DART AEROSPACE LTD		Work Order:	97409
Description: Crosstube Assembly		Part Number:	D206-667-243
Inspection Dwg: D206-667-243 Rev: C		Page 1 of 2

DESIGN	97	DART AEROSPACE LTD	
DRAWN	RF	HAWKESBURY, ONTARIO, CANADA	
CHECKED	47	DRAWING NO.	REV. C
MFG. APPR.	47	D206-667-243	SHEET 4 OF 4
APPROVED	47	TITLE	SCALE
DE APPR.	47	CROSSTUBE ASS'Y (206L HIGH AFT)	NTS
DATE	08.11.06	COPYRIGHT © 2000 BY DART AEROSPACE LTD THIS DOCUMENT IS PRIVATE AND CONFIDENTIAL, AND IS SUPPLIED ON THE EXPRESS UNDERSTANDING THAT IT IS NOT TO BE USED FOR ANY PURPOSE OR COPIED OR COMMUNICATED TO ANY OTHER PERSON WITHOUT WRITTEN PERMISSION FROM DART AEROSPACE LTD.

DRAWING NO. D206-667-243	TITLE CROSSTUBE ASS'Y (206L HIGH AFT)	REV. C	DART AEROSPACE LTD ENGINEERING ORDER		D.E.O. NO. D206-667-243-C-1	SHEET NO. SHEET 1 OF 1	SCALE NTS
DRAWN <i>qp</i>	CHECKED <i>ASS</i>	MFG. APPR. <i>RB</i>	APPROVED <i>MD</i>	DE APPR. <i>#</i>			
DATE 11.07.15	DATE 11.07.20	DATE 11.07.21	DATE 11/07/21	DATE 11.07.21

REPLACE MAGNOBOND WITH PROSEAL.

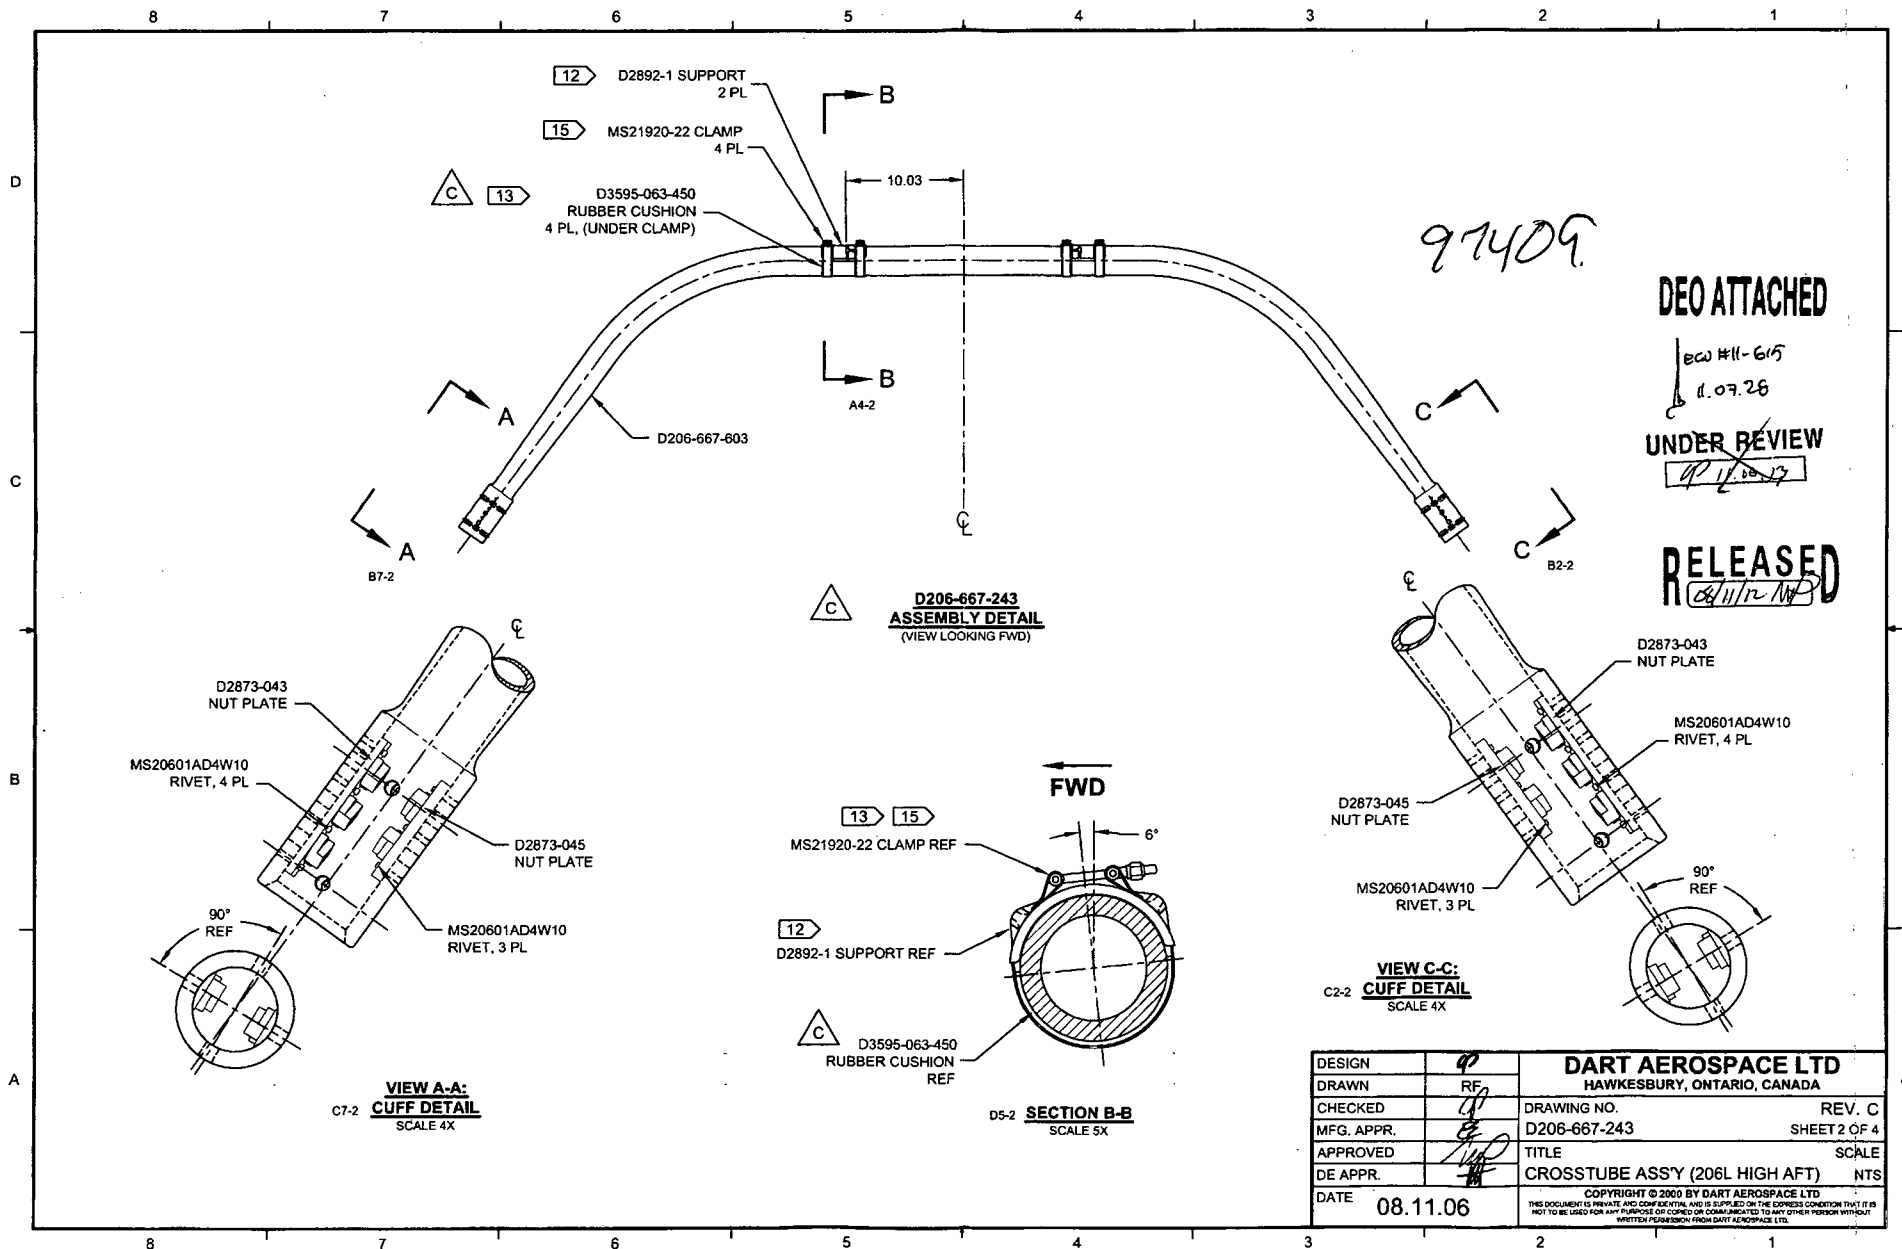
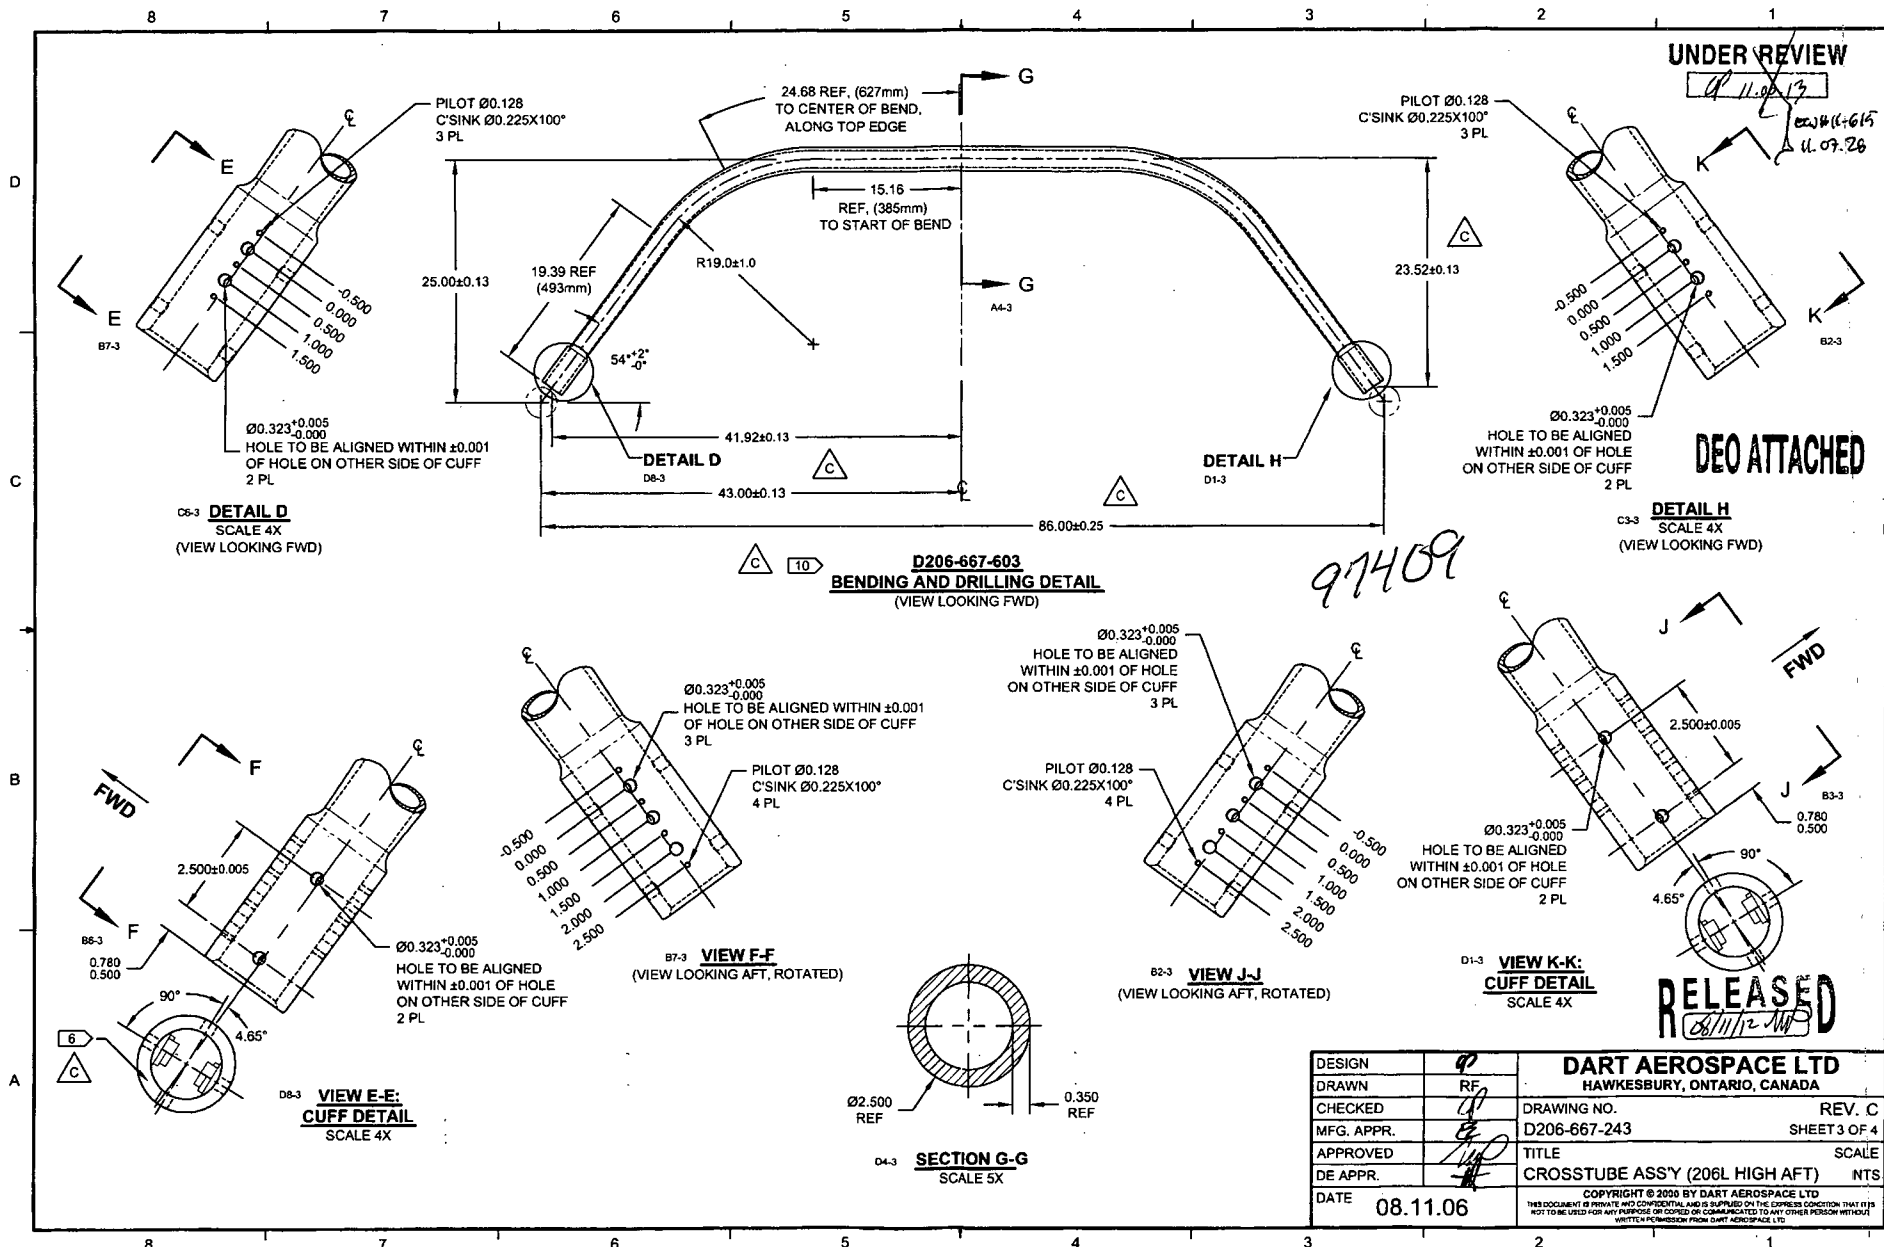
IS:

Item	Qty -243	Part Number	Description
9	A/R	PROSEAL 890 B-2	SEALANT, AMS-S-8802 CLASS B-2

WAS:

9	A/R	MAGNOBOND 6398	ROCKWELL SPECIFICATION RBO-120-023 ADHESIVE (TEXTRON/BELL SPEC. 299-947-100, TYPE II, CLASS 2 ADHESIVE)
---	-----	----------------	---

NOTE 12 & 15, SHEET 1 IS AMENDED AS FOLLOWS:

WAS:

12) INSTALL D2892-1 SUPPORT USING 0.03" TO 0.06" THICK LAYER OF MAGNOBOND 6398 PER QSI 015. LET CURE FOR 12 HOURS AFTER INSTALLATION AND PRIOR TO PACKAGING.

15) TORQUE CLAMPS 80 TO 100 IN-LB. ENSURE AT LEAST 1.5 THREADS SHOWING IN SAFETY AND THAT NUT HAS NOT BOTTOMED-OUT AFTER TORQUING.

12) TO INSTALL D2892-1 SUPPORT: ABRASE MATING SURFACE OF SUPPORT AND CROSSTUBE WITH 180-GRIT SANDPAPER AND REMOVE RESIDUE WITH MEK (OR EQUIVALENT). APPLY A 0.04" TO 0.07" THICK LAYER OF PROSEAL 890 CLASS B-2 (OR AMS-S-8802 CLASS B-2) SEALANT TO MATING SURFACE OF SUPPORT.

15) TORQUE CLAMPS 80 TO 100 IN-LB. ENSURE AT LEAST 1.5 THREADS SHOWING IN SAFETY AND THAT NUT HAS NOT BOTTOMED-OUT AFTER TORQUING. **PRIOR TO PACKAGING, RE-CHECK TORQUE ON CLAMPS AFTER PROSEAL 890 SEALANT HAS CURED FOR 72 HOURS.**
